ADDRESS: 1924 AND 1940 FAIRMOUNT AVE

Proposal: Construct new three-story mixed use building

Review Requested: Final Approval

1924 and 1940 Fairmount Ave
Philadelphia Historical Commission
November/December 2025

PROPOSED NORTH ST
ELEVATION

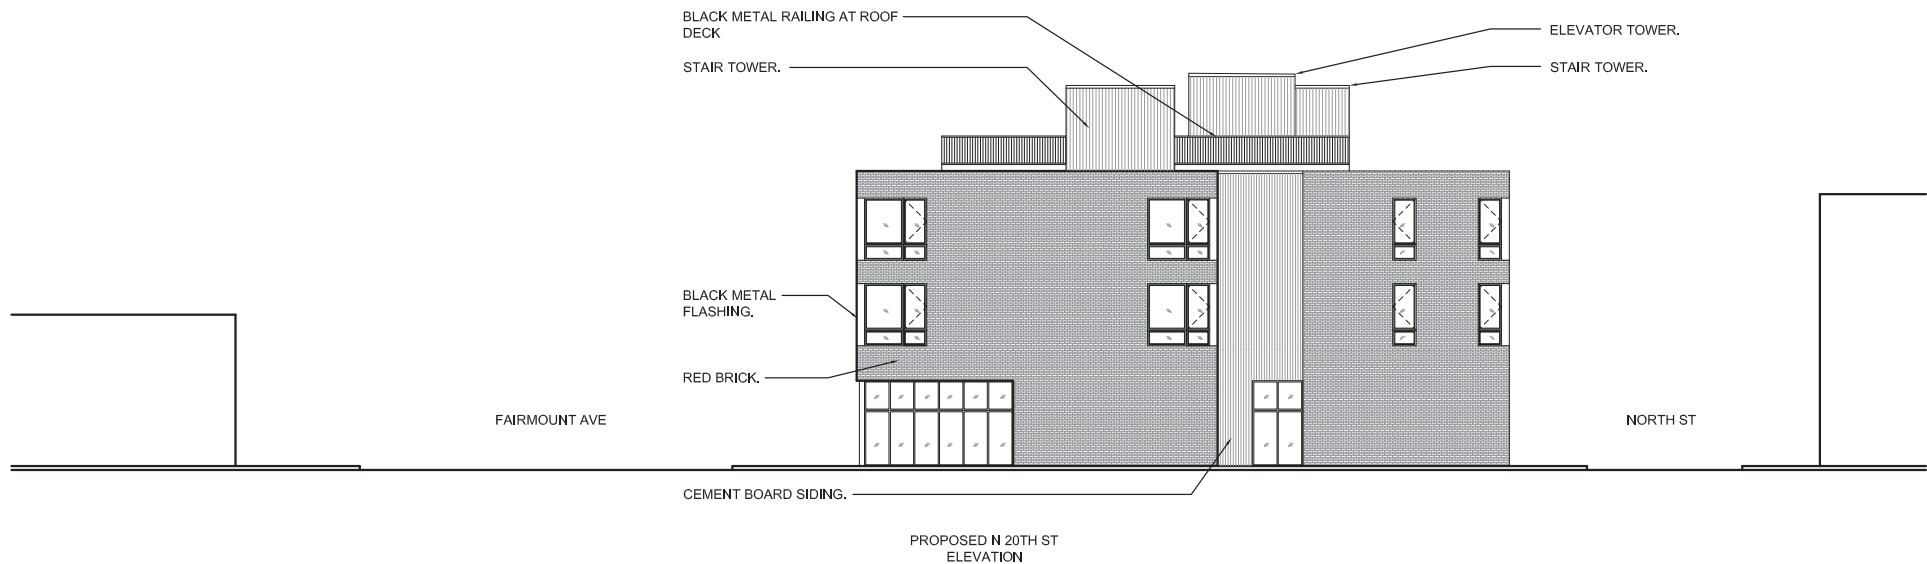
- The setback areas with the dark cladding at the second and third floors break the street wall that is emphatically maintained throughout the historic district. While the setback areas do establish rowhouse-width modules, the shadowy open areas with balconies are unlike anything in the historic district. The setbacks should be eliminated and the street wall maintained.

STAFF RECOMMENDATION: Approval, provided the setback areas with balconies are eliminated, cornices are added, and the horizontality is replaced with a verticality with a rowhouse-width rhythm, pursuant to Standard 9.
